City of Mississauga Department Comments

Date Finalized: 2022-05-04	File(s): A239.22 Ward 8
To: Committee of Adjustment	
From: Committee of Adjustment Coordinator	Meeting date:2022-05-12 1:00:00 PM

Property Address: 3350 Tudor Gate

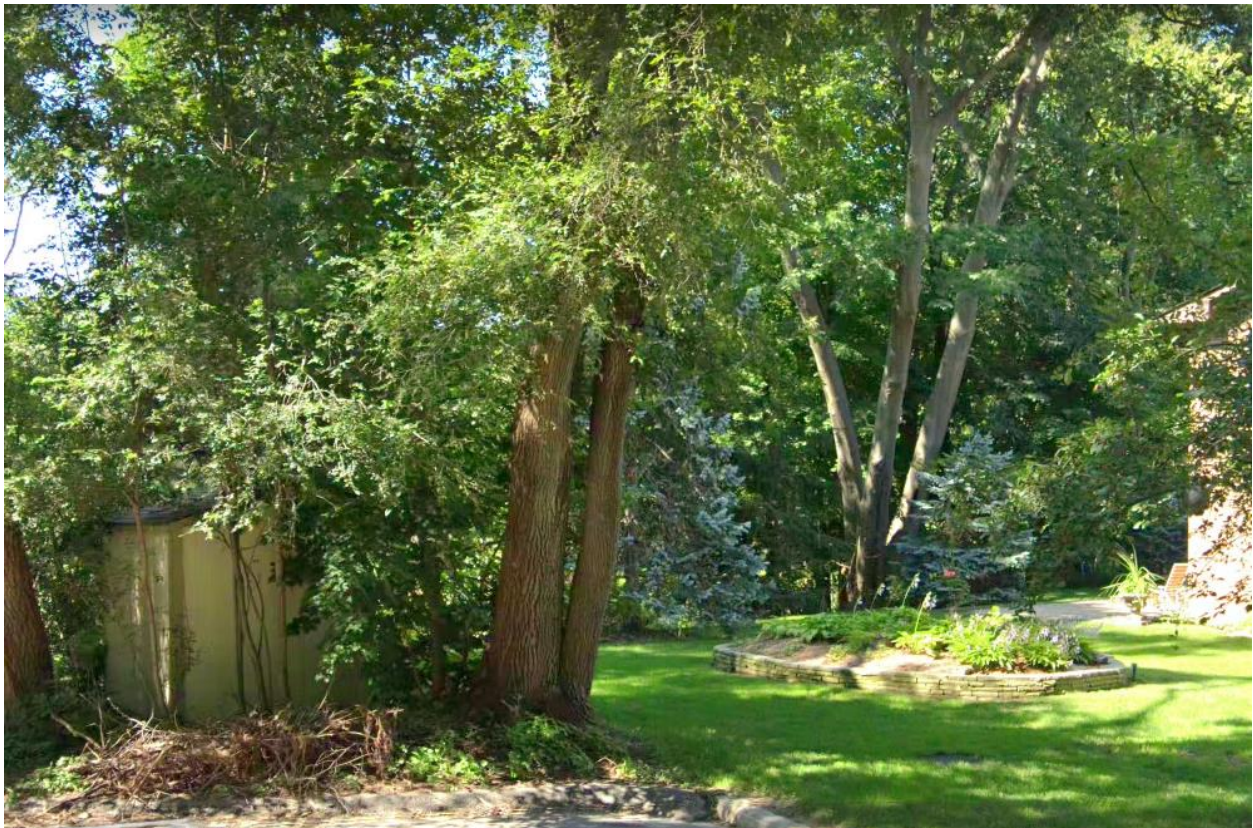
Enclosed you will find photos of the area where the pool and structure are proposed. This Department does not have a concern with the applicant's proposal; however, we do have a concern with the existing woodshed that has been constructed within the municipal boulevard area at the terminus of Harkiss Road. We request that the shed be removed from within the municipal boulevard and relocated onto private property. In addition, we would request that the proposed gate that is shown on the Tudor Gate side in proximity to the existing illegal shed be removed so as not to encourage access to the illegal shed. This department would support a deferral of the application to have the plans show the existing shed to be removed and/or relocated out of the municipal boulevard.
